# **Seismic Provisions for Structural Steel Buildings (1997) Supplement No. 1**

February 15, 1999

Fig. C-13.2. Brace-to-gusset plate requirement for buckling out-of-plane bracing system.

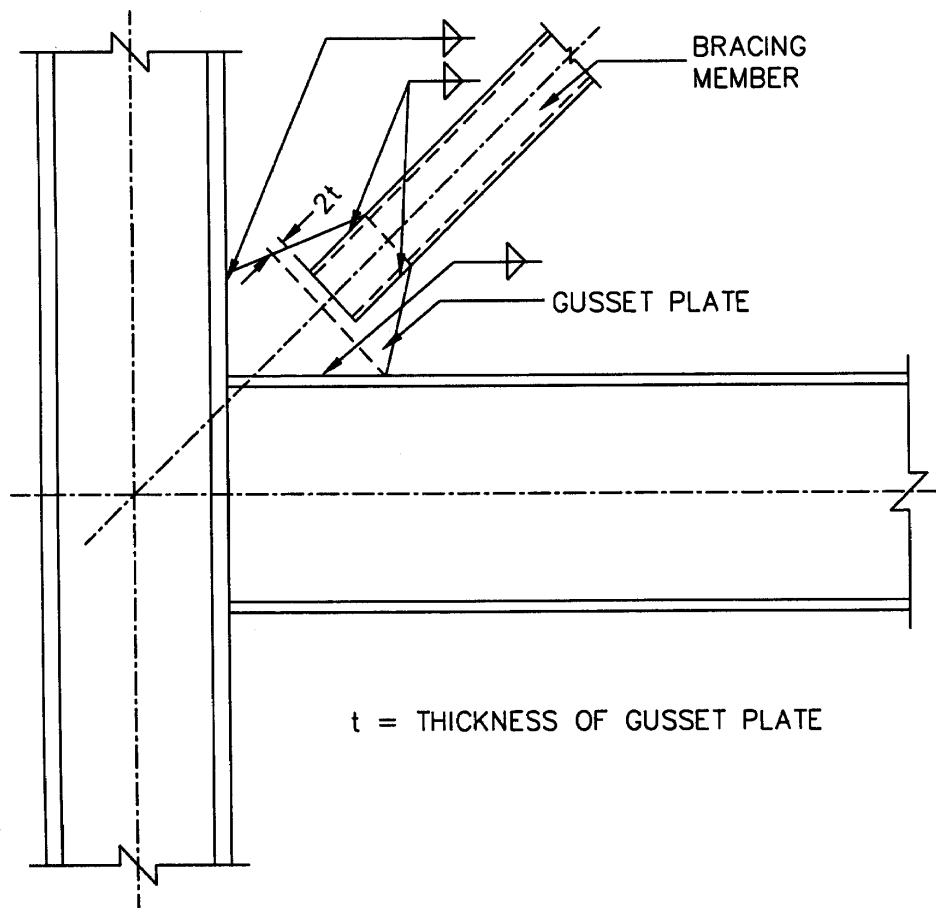
**17. Commentary Figure C-13.2**

Replace the existing Figure C-13.2 with the attached Figure C-13.2.
